LS1012A silicon changes from revision 1.0 to revision 2.0

Document Number AN11980 Revision 0, 01/2018

Table 3. MAC to PHY and MAC to MAC clocking scheme

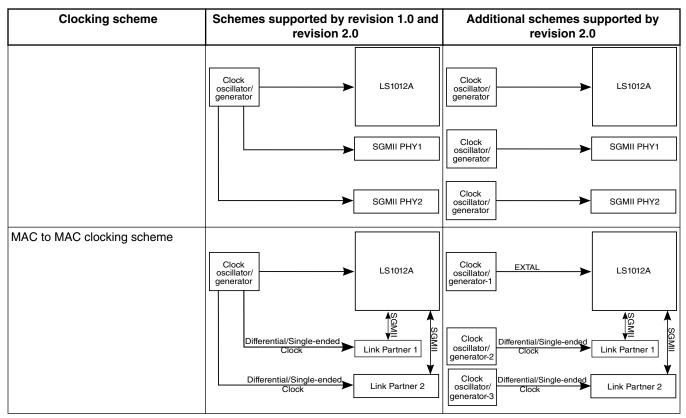
LS1012A revision 1.0 requires common clock for LS1012A and its link partner for proper operation of SGMII (10/100/1000/2500 Mbps). Refer erratum Ethernet A-010336.

Ethernet A-010336 is fixed in LS1012A revision 2.0.

Changes in clocking requirement are shown below:
